Supplement to the Environmental Assessment and Finding of No Significant Impact

Auld-Brokaw Trail Repair and Marne Creek Bank Stabilization

City of Yankton, Yankton County, South Dakota

November 2022

Attachment 1 - Cross Sections

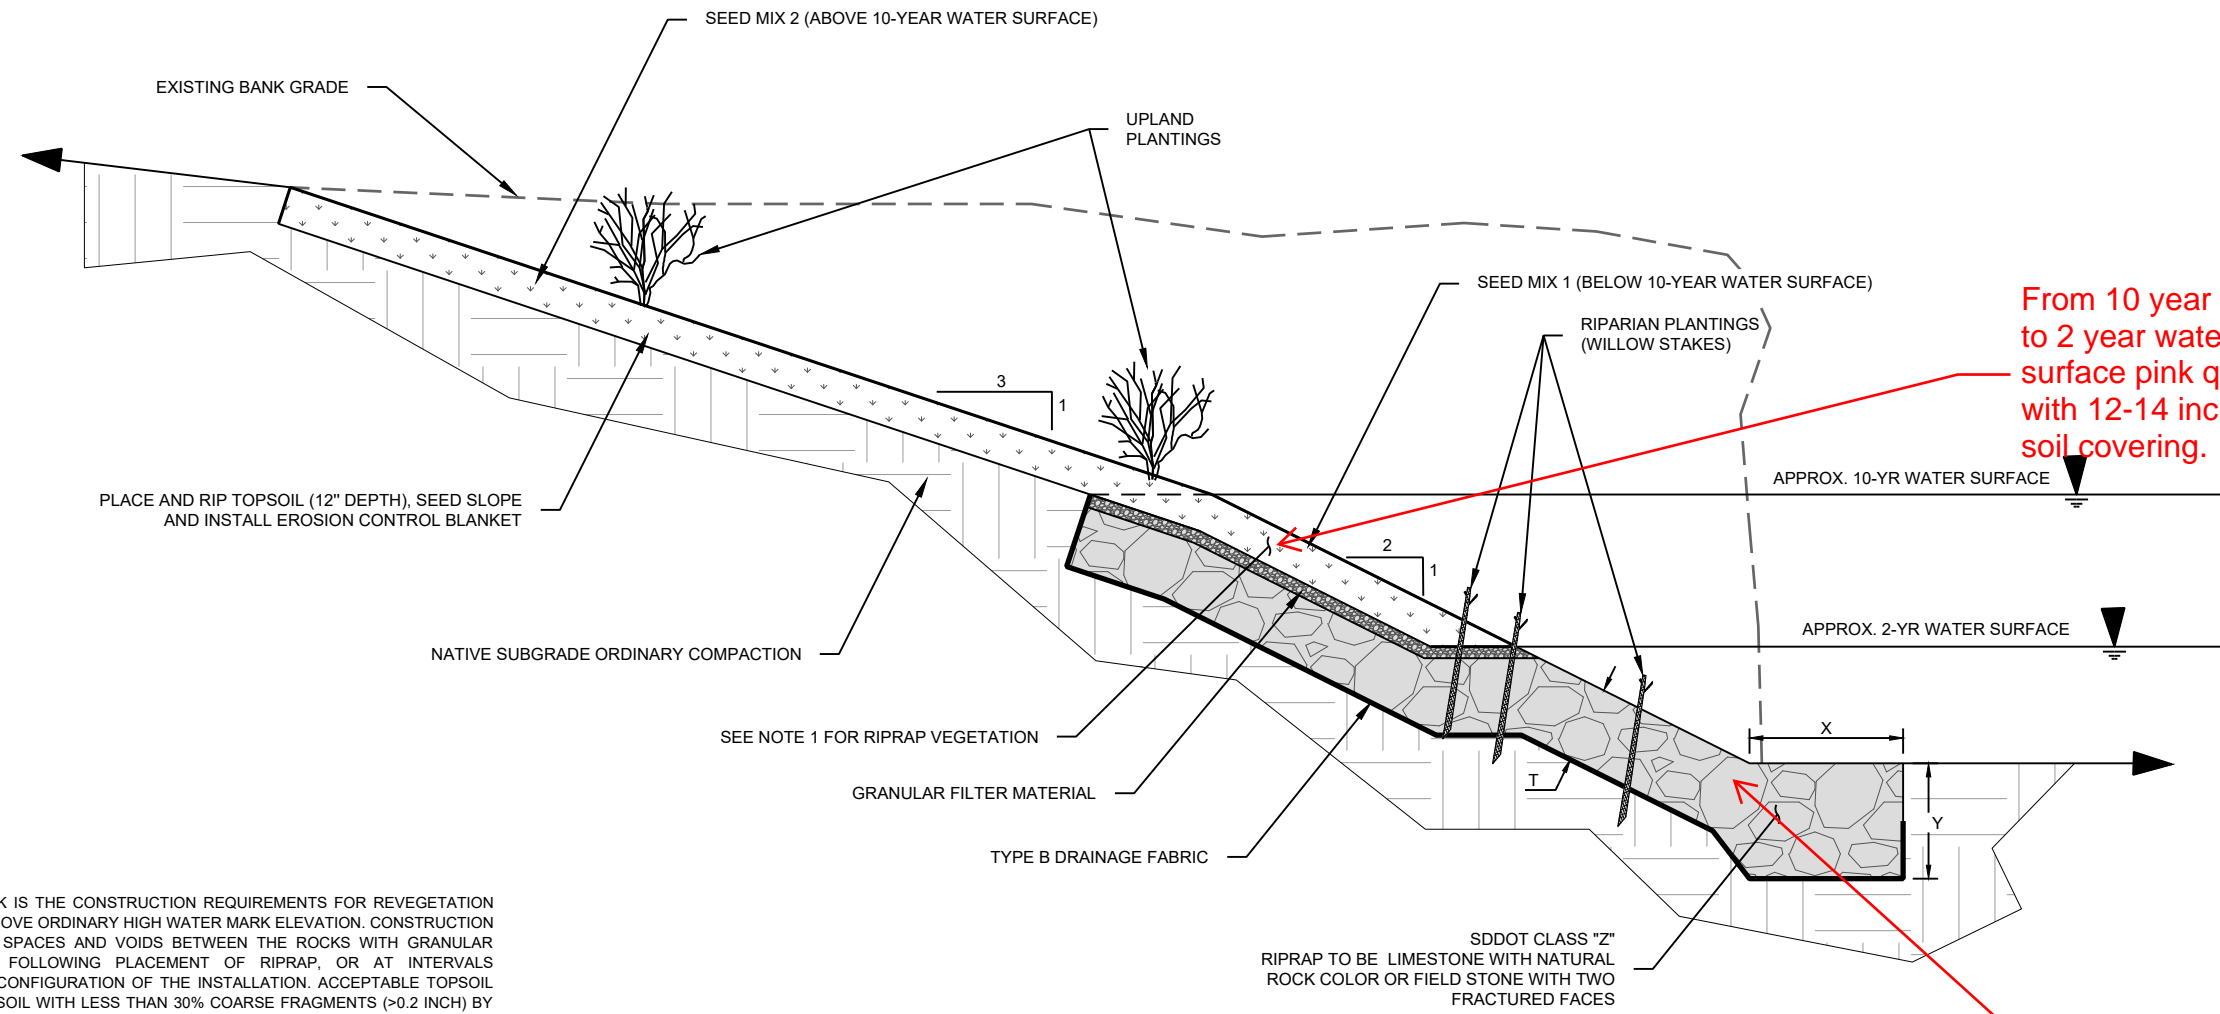
The final design included substituting quarried pink quartzite for a portion of the riprap with an overlay of field stone or native rock. Installation of quarried pink quartzite reduced the quantity of field stone or native rock, thus reducing the cost of field stone or native rock installation. The revision is only applied to Reach A within Action Alternative 2.

The final revision for Reach A will use pink quartzite as the main material for riprap, covered by soil, field stone or native rock so the pink quartzite is not visible. Refer to Attachment 1 for the revised cross section. The revision allows for a cost-effective riprap installation by utilizing both types of material. The revision is an option for compliance under the NPS Conditions. Refer to Attachment 2.

From 10 year surface to 2 year water surface pink quartzite with 12-14 inches of soil covering.

From 2 year water surface to bottom of channel, pink quartzite covered by field rock or native stone so the quartzite is not visible.

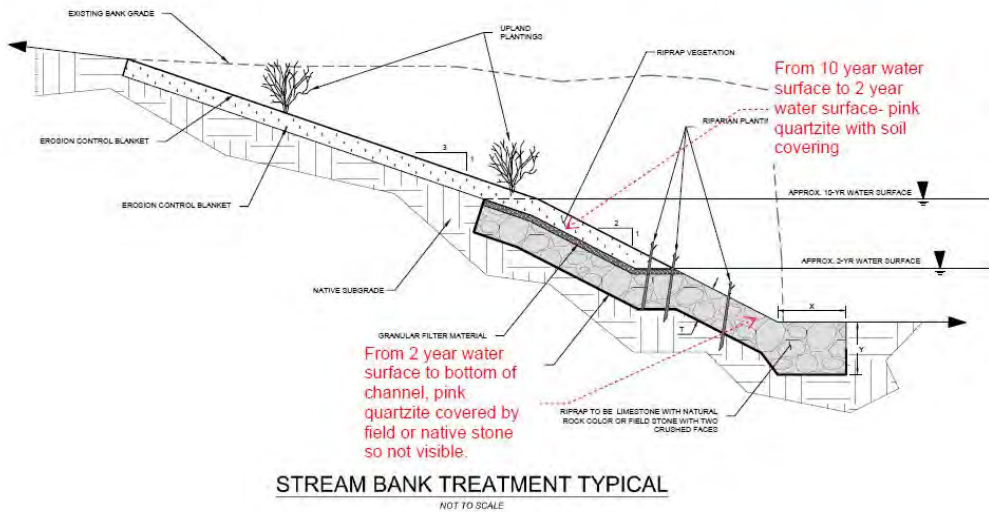
Thanks for the discussion. As I mentioned, our original intent was to utilize native and field stone for the riprap in Reach A. We are finding costs for native and field stone to be high. So looking for ways to meet commitments and still be able to complete the project. In the NPS conditions, it notes quarried pink quartzite shall be covered with fieldstone and native rock and a minimum of 12-14 inches of soil. With the following diagram:

We are proposing to follow this and here is a marked up cross section. We note from 10 year to 2 year, it would be pink quartzite covered by soil. From 2 year to bottom of channel, pink quartzite covered by field or native stone. Both coverings would be thick enough so the pink quartzite could not be visible.

Could you please confirm if this revised approach would be acceptable to meet the NPS conditions? As I mentioned, if acceptable, we are going to issue an addendum on Friday. Bid is due next week so we want to see if we can get more cost effective bids to be able to have the project proceed. Please do not hesitate if you need further information.

Thank you for sending the email with the diagrams. I confirmed with my supervisor and the regional expert that the revised approach will work for us.

If you can make sure the stipulation is clear about no pink quartzite being visible and every effort should be made to ensure this in addendum like you have in the drawings and the explanation, then we are good with proceeding.

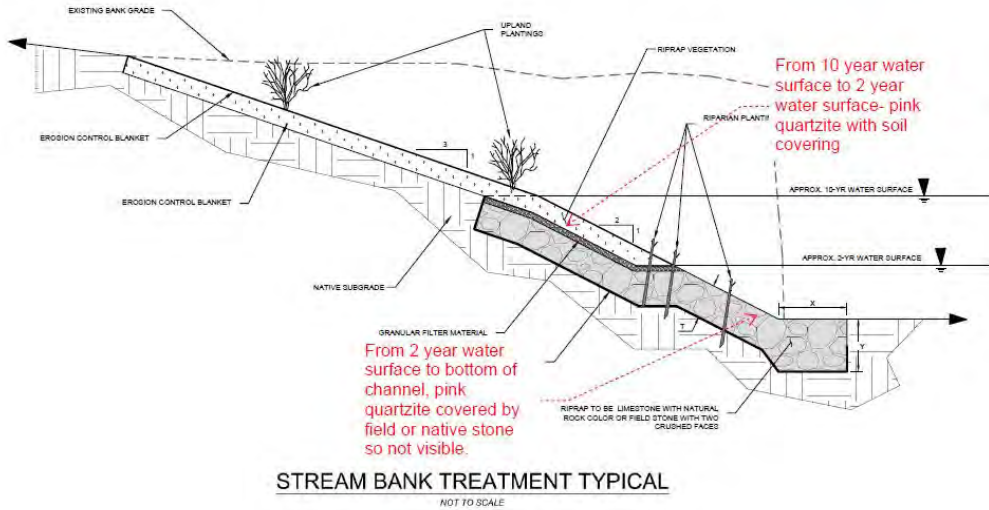
Thanks for the discussion. As I mentioned, our original intent was to utilize native and field stone for the riprap in Reach A. We are finding costs for native and field stone to be high. So looking for ways to meet commitments and still be able to complete the project. In the NPS conditions, it notes quarried pink quartzite shall be covered with fieldstone and native rock and a minimum of 12-14 inches of soil. With the following diagram:

We are proposing to follow this and here is a marked up cross section. We note from 10 year to 2 year, it would be pink quartzite covered by soil. From 2 year to bottom of channel, pink quartzite covered by field or native stone. Both coverings would be thick enough so the pink quartzite could not be visible.

Could you please confirm if this revised approach would be acceptable to meet the NPS conditions? As I mentioned, if acceptable, we are going to issue an addendum on Friday. Bid is due next week so we want to see if we can get more cost effective bids to be able to have the project proceed. Please do not hesitate if you need further information.
